<b>Title - Sujet</b> Jasper Staff Housing Project	
<b>Solicitation No. - N° de l'invitation</b> EW038-202718/A	<b>Amendment No. - N° modif.</b> 001
<b>Client Reference No. - N° de référence du client</b> PCA-EW038-202718	<b>Date</b> 2020-03-20
<b>GETS Reference No. - N° de référence de SEAG</b> PW-\$PWU-201-11819	
<b>File No. - N° de dossier</b> PWU-9-42246 (201)	<b>CCC No./N° CCC - FMS No./N° VME</b>
<b>Solicitation Closes - L'invitation prend fin</b> <b>at - à 02:00 PM</b> <b>on - le 2020-04-17</b>	<b>Time Zone</b> Fuseau horaire Mountain Daylight Saving Time MDT
<b>F.O.B. - F.A.B.</b> <b>Plant-Usine:</b> <input type="checkbox"/> <b>Destination:</b> <input type="checkbox"/> <b>Other-Autre:</b> <input type="checkbox"/>	
<b>Address Enquiries to: - Adresser toutes questions à:</b> Ho (RPC), Hector	<b>Buyer Id - Id de l'acheteur</b> pwu201
<b>Telephone No. - N° de téléphone</b> (780) 901-0989 ( )	<b>FAX No. - N° de FAX</b> (780) 497-3510

# JASPER STAFF HOUSING CONSTRUCTION

## 5 PLEX

### *ADDENDUM No. 1*

# 5plex Landscaping Plan

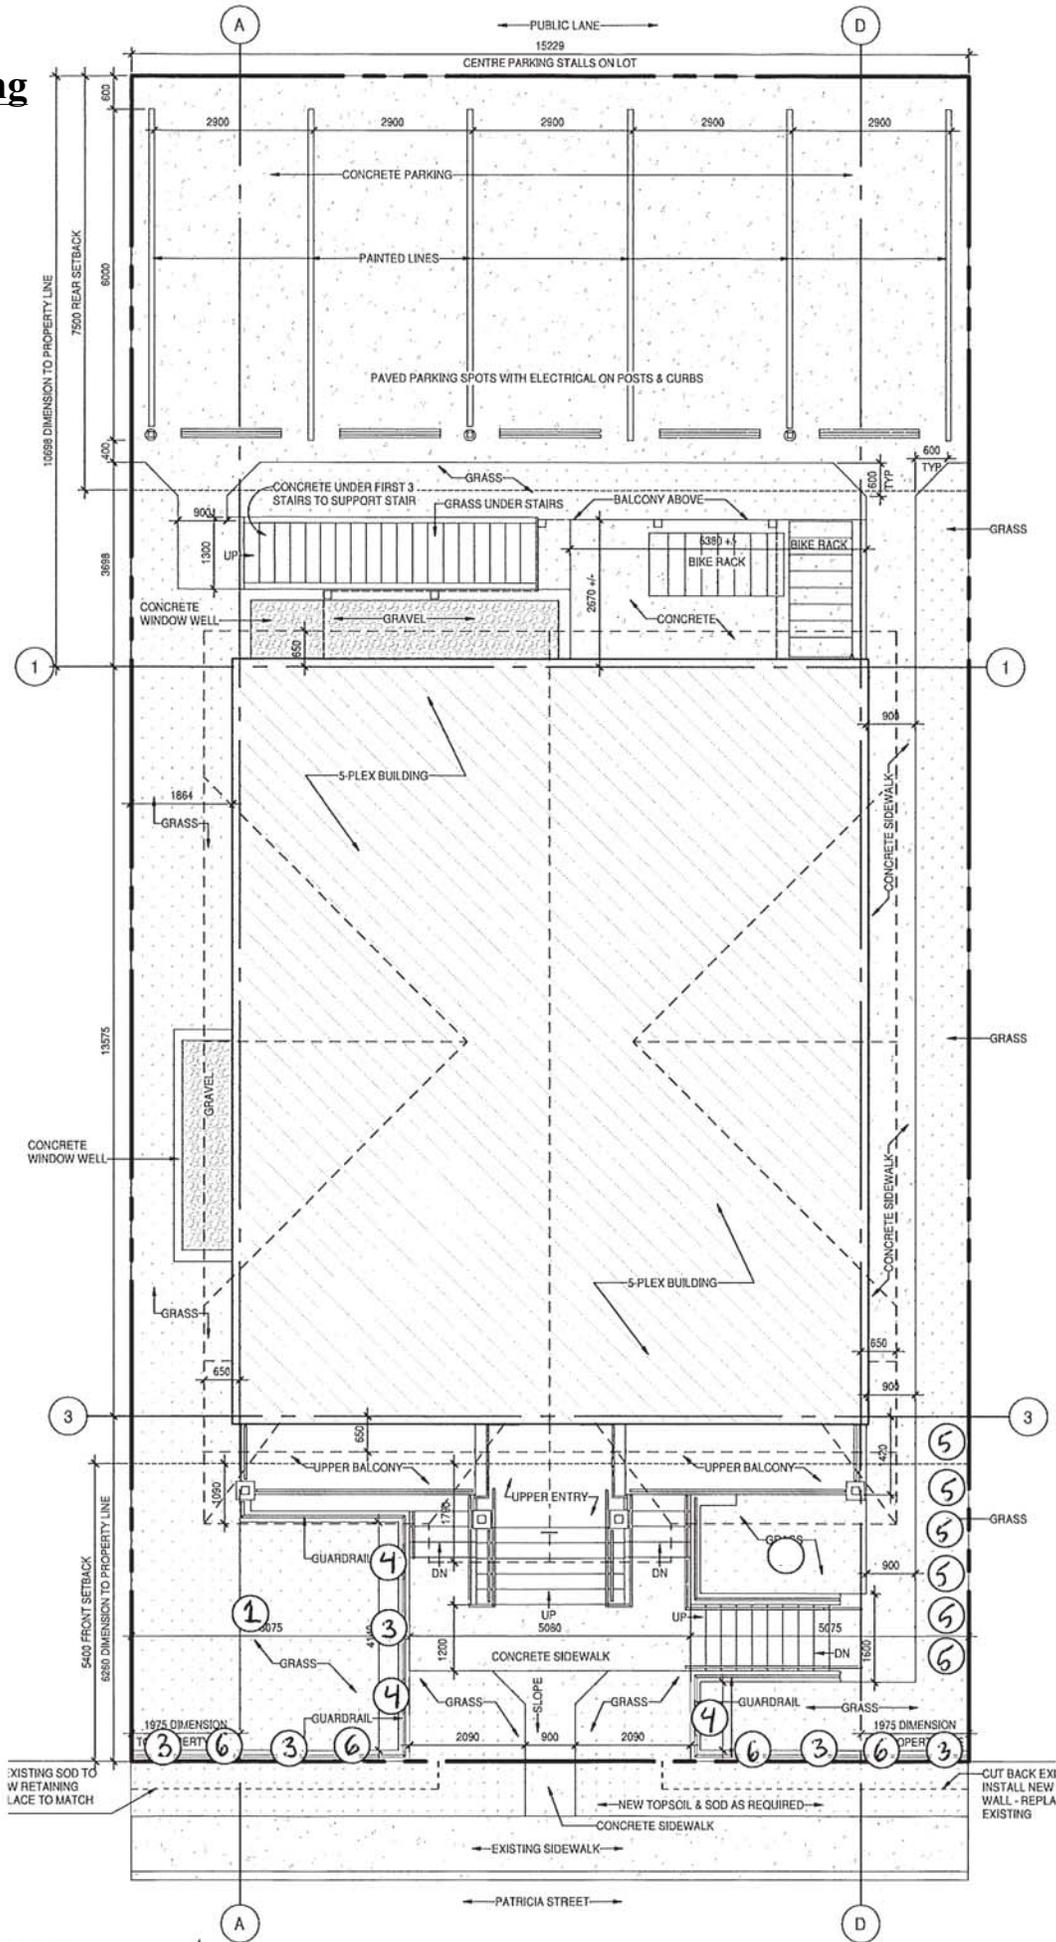
- C.** Refer to attached landscaping plan. Supply and install trees and shrubs, as identified on the plan. All grassed or sod areas identified on both Dwgs A1.0 and on the Landscaping Plan are to be sod with a minimum 100mm depth of topsoil.
